NOTICE TO CONTRACTOR

APPROVED

McKee Homes, LLC
Lot 1019 Anderson Creek Carriage Glen
Torino II Craftsman
RH Monoslab Foundation

ROOF PLAN W/ OPT. COVERED PORCH

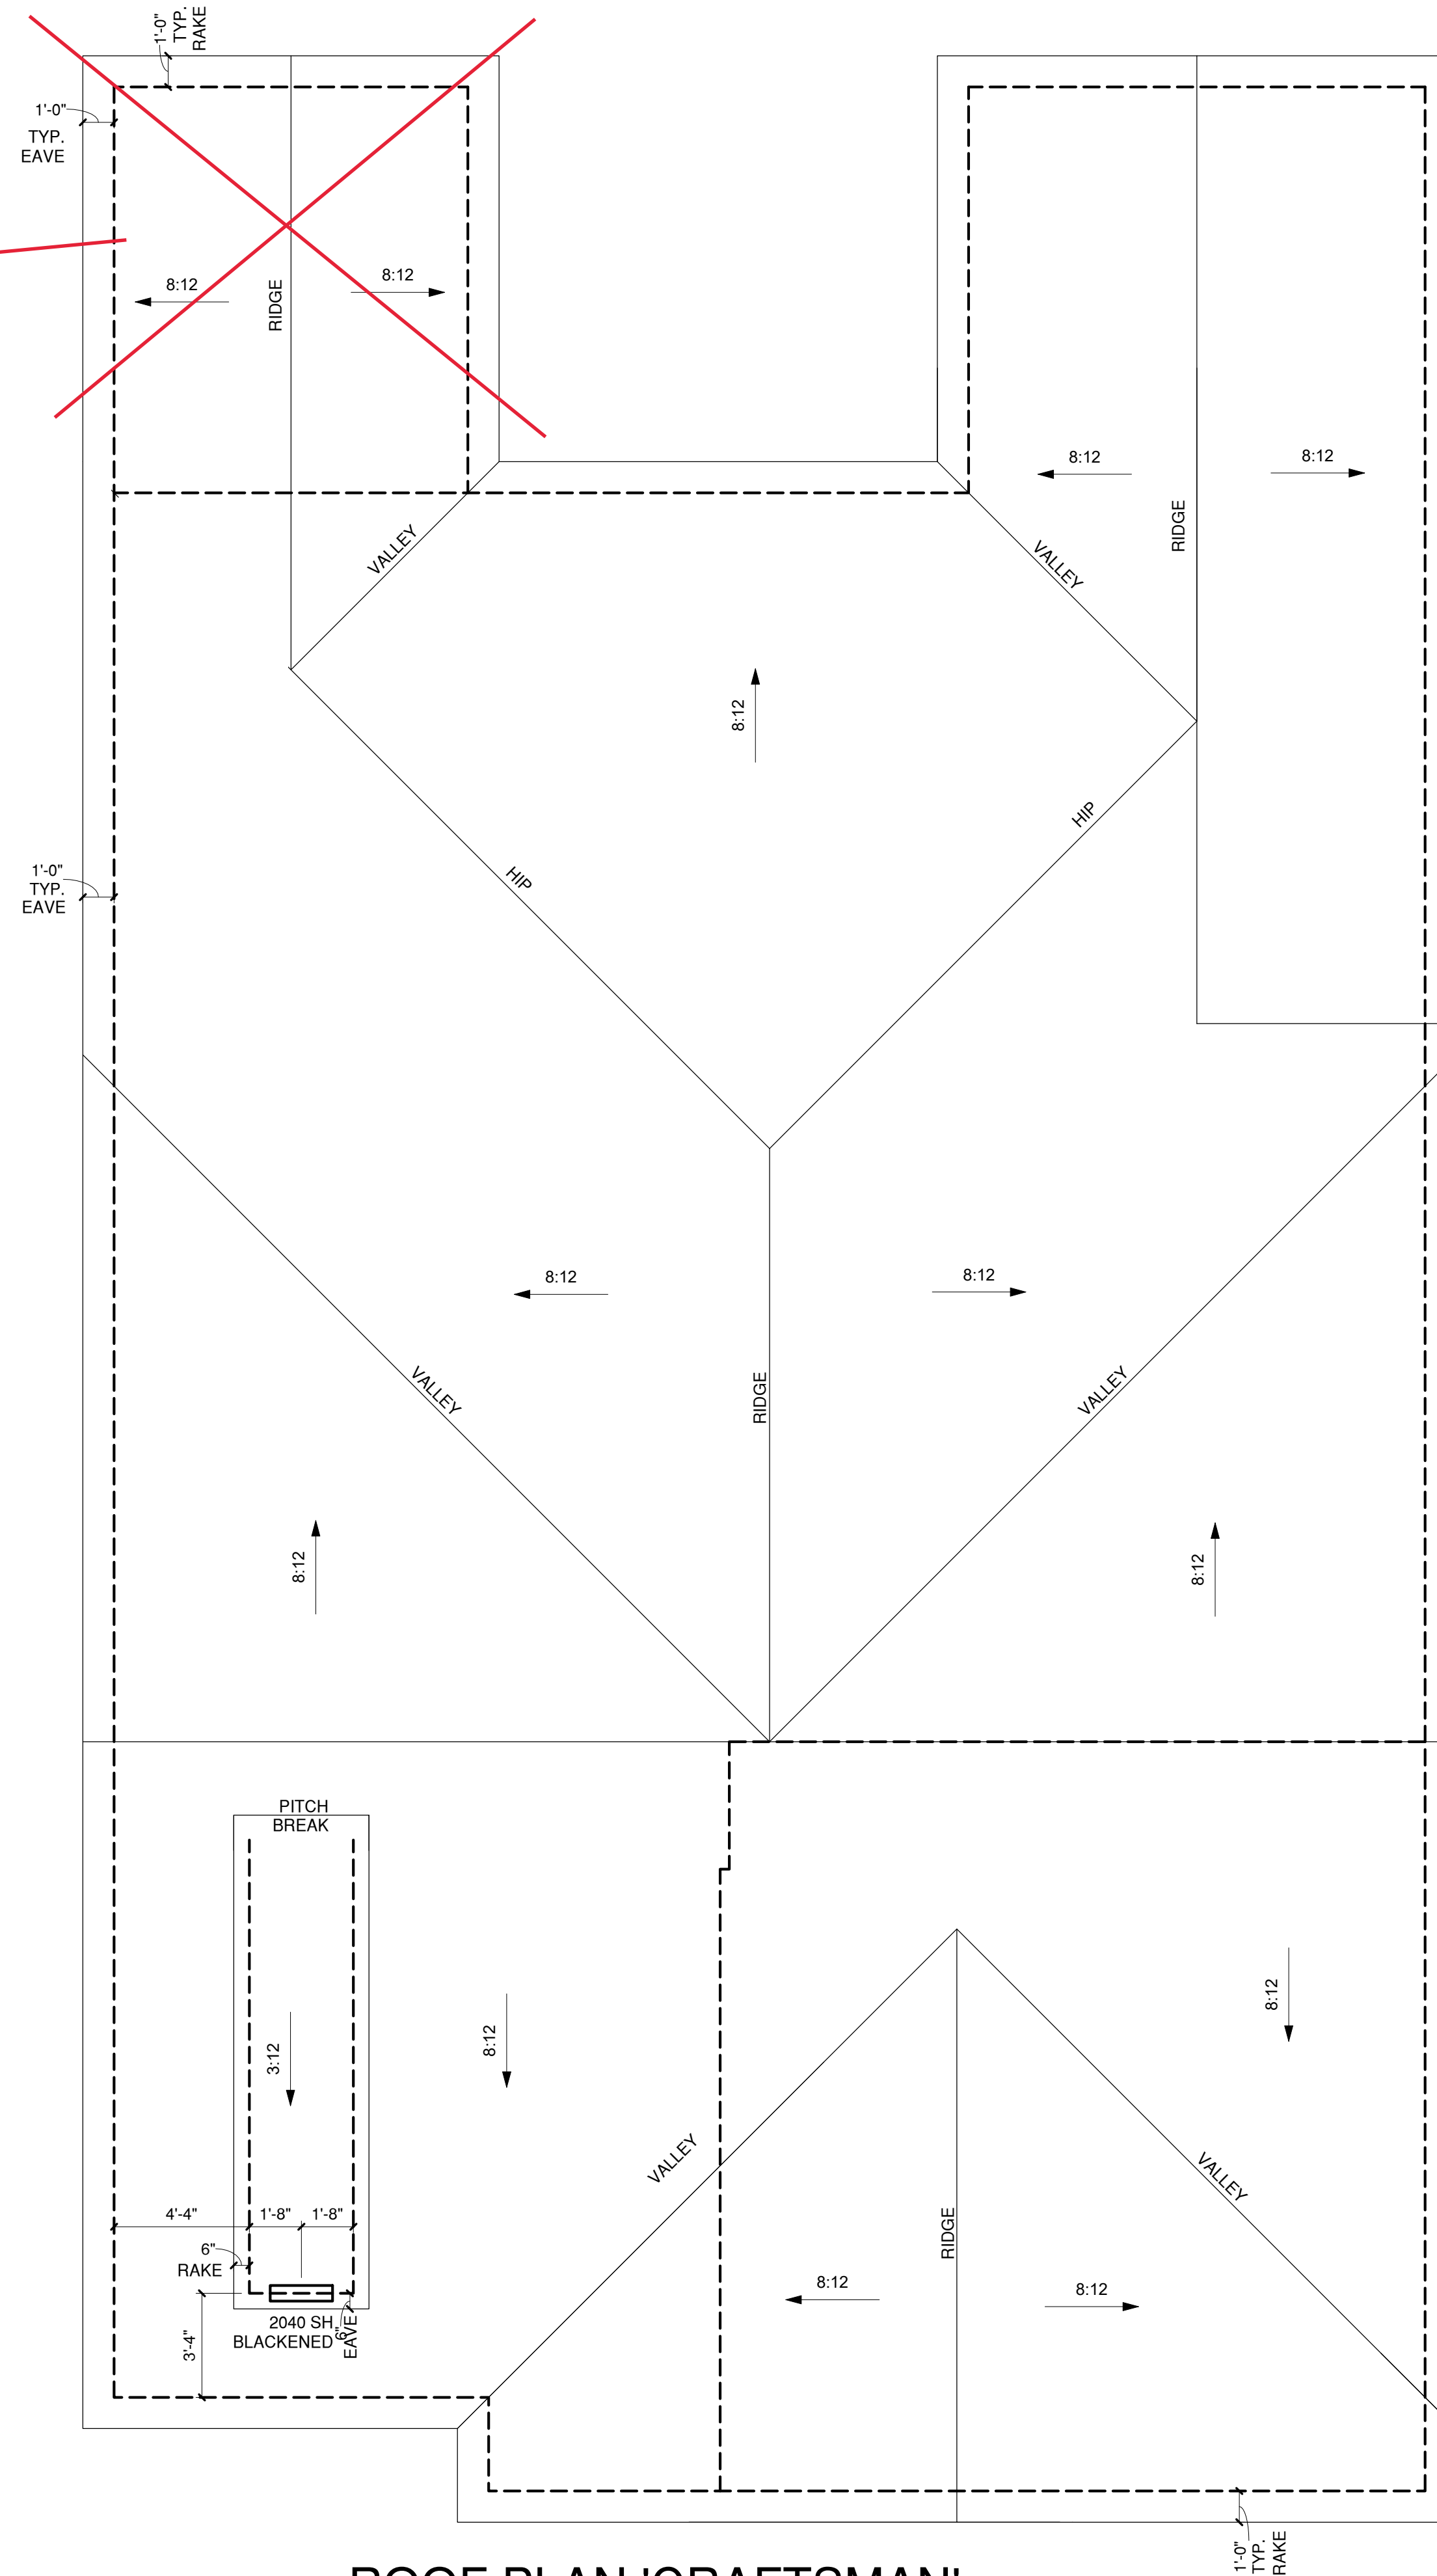
USE THIS COVERED PORCH

OPT. COVERED PORCH
 1/4" = 1'-0" AT 22'X34" LAYOUT 1/8" = 1'-0" AT 11' X 17' LAYOUT

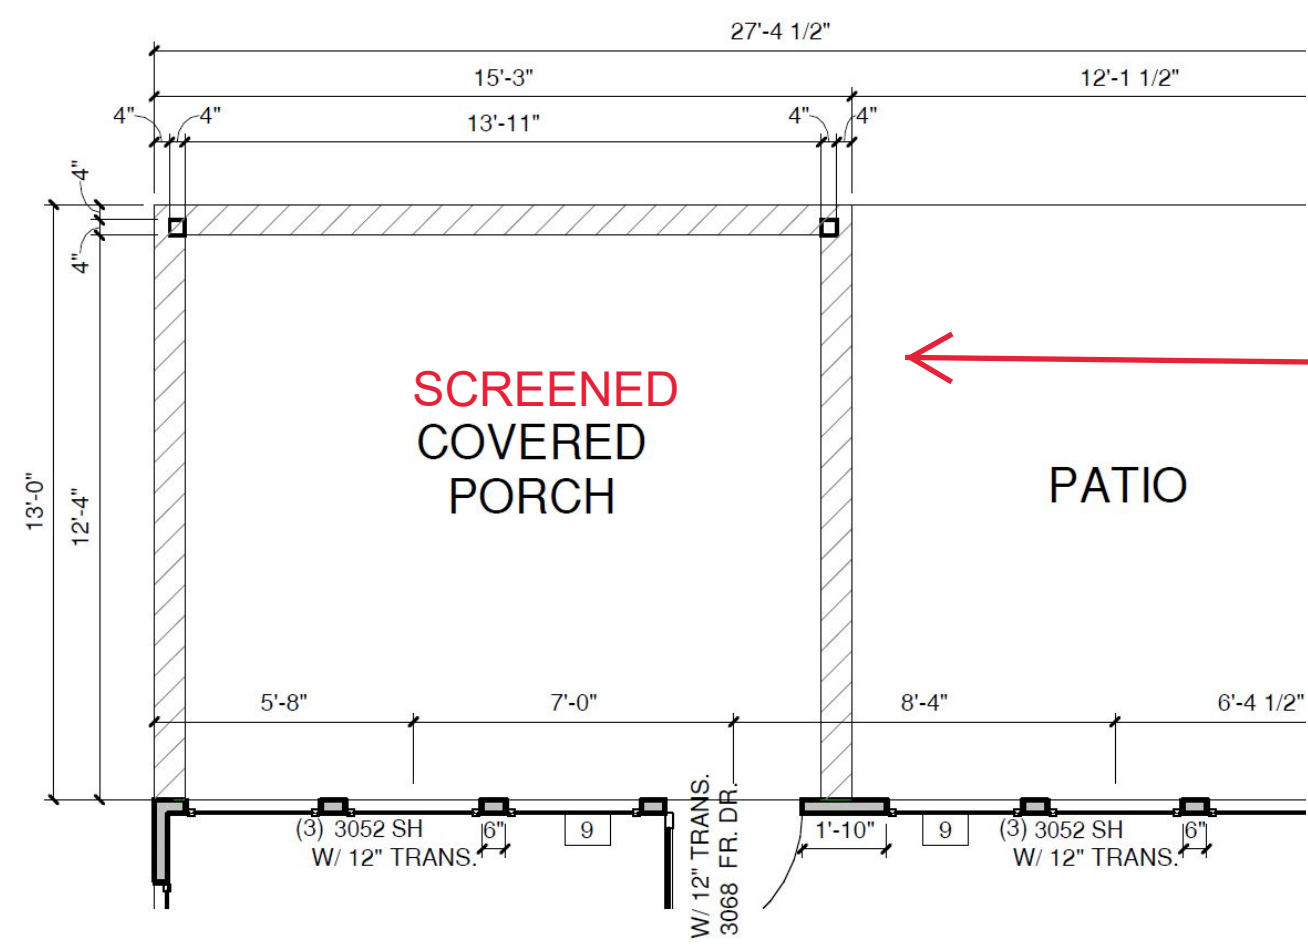
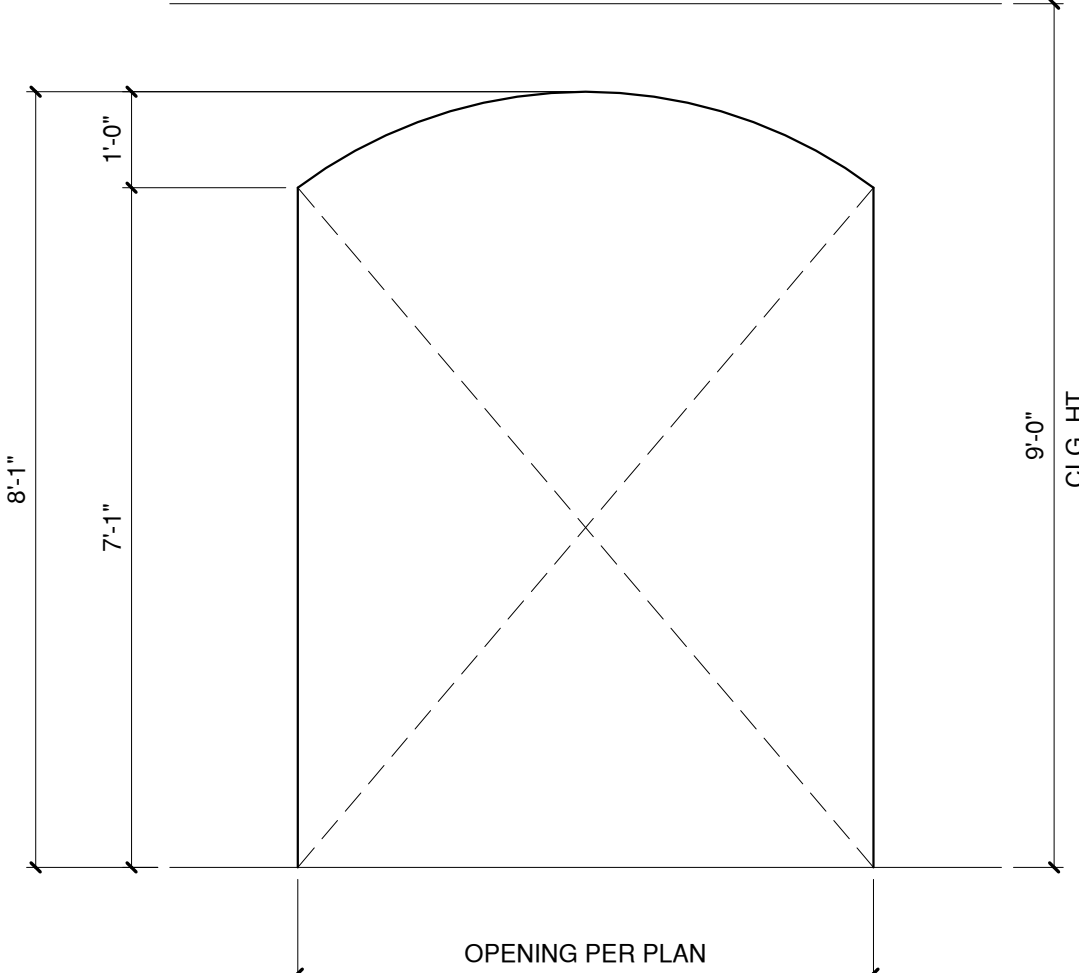
USE THIS COVERED PORCH

OPT. COVERED PORCH UTILITY PLAN

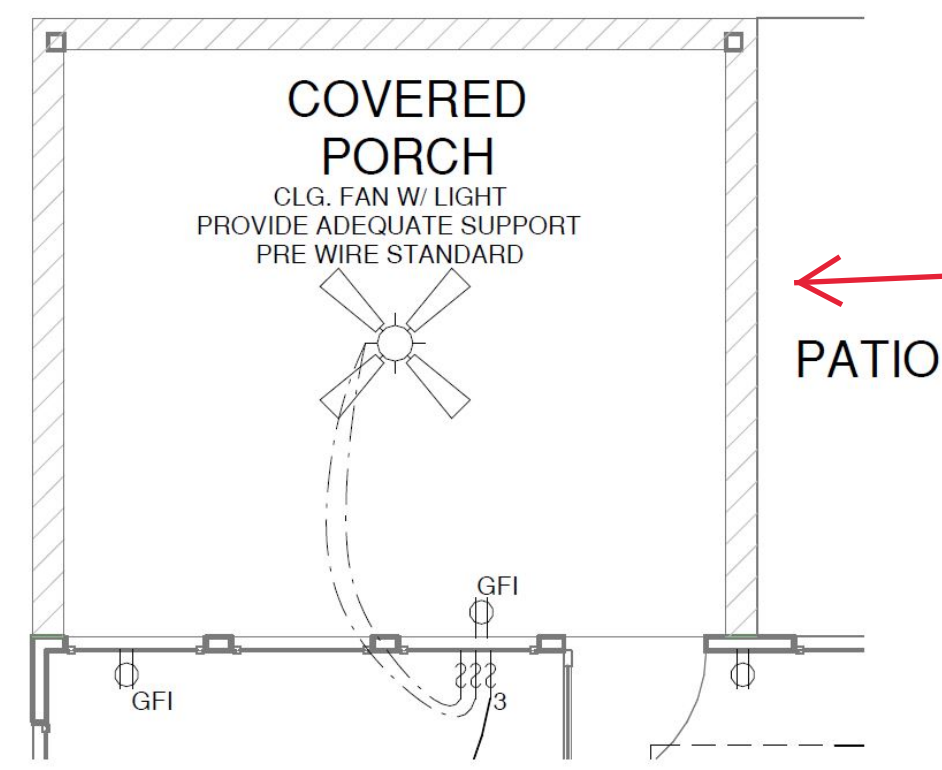
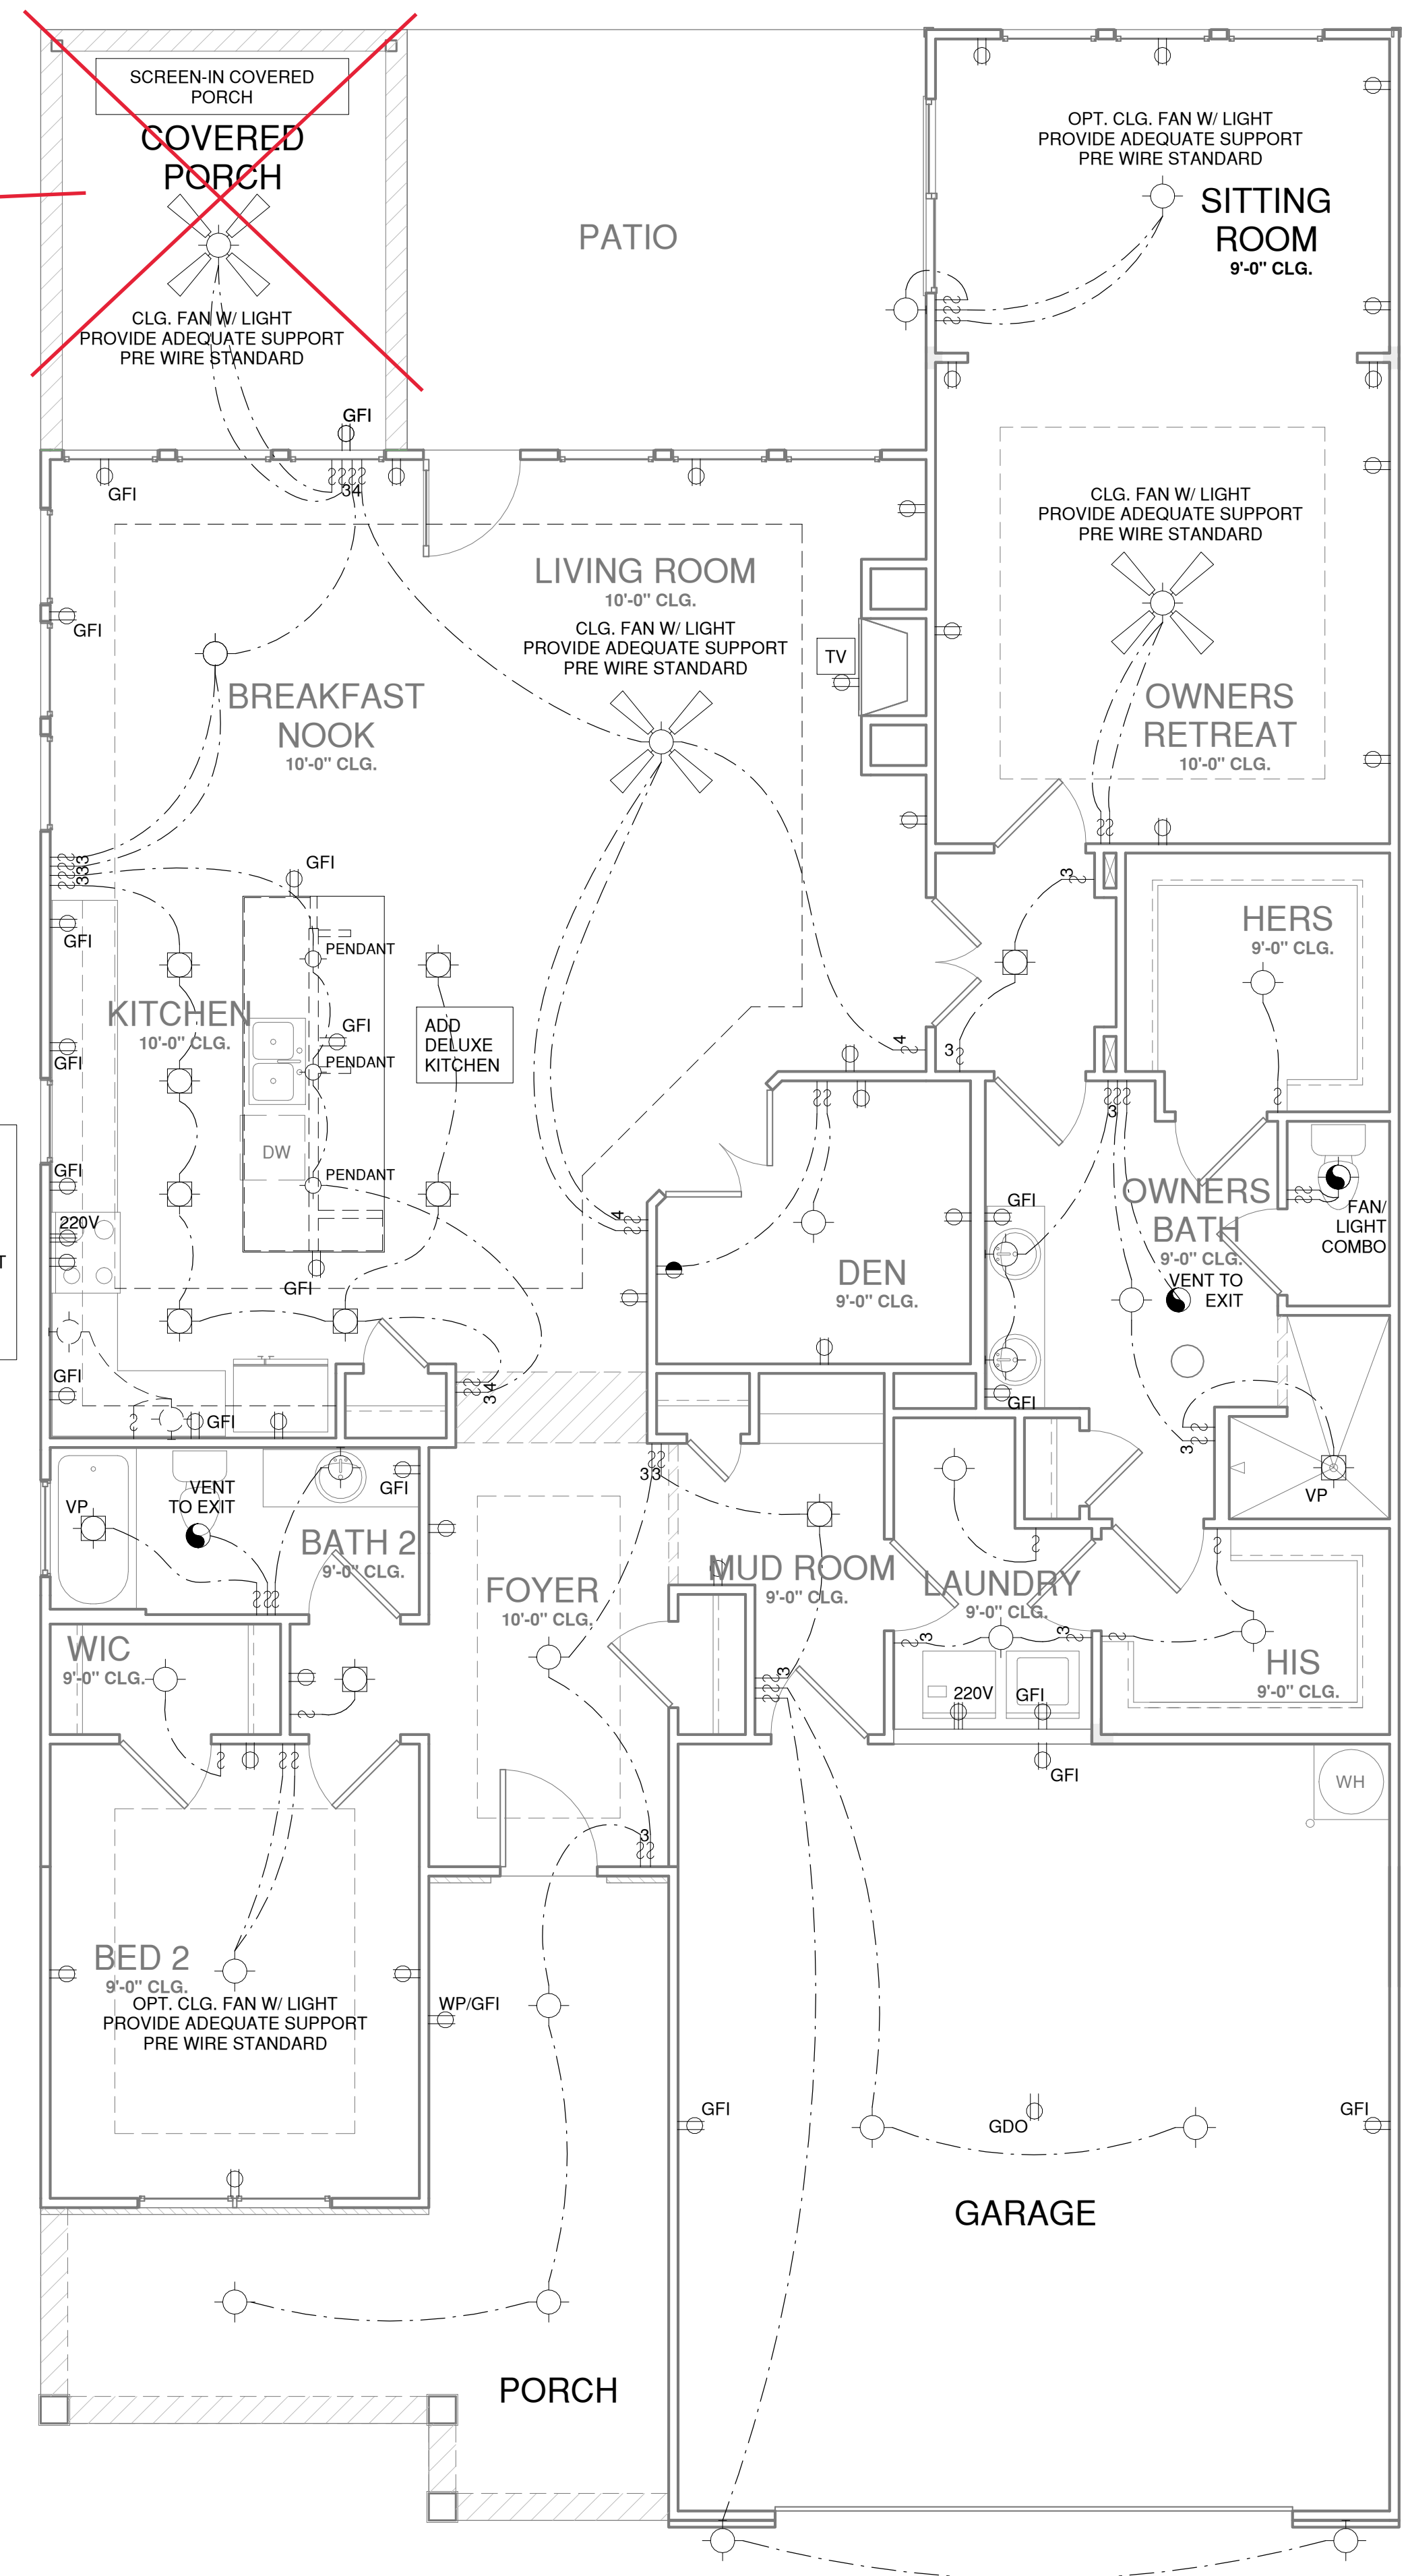
USE THIS COVERED PORCH

ONLY ONE PHONE LINE INCLUDED IN BASE HOUSE
ADD UNDERCABINET LIGHTING - INSTALL OUTLETS AS STANDARD
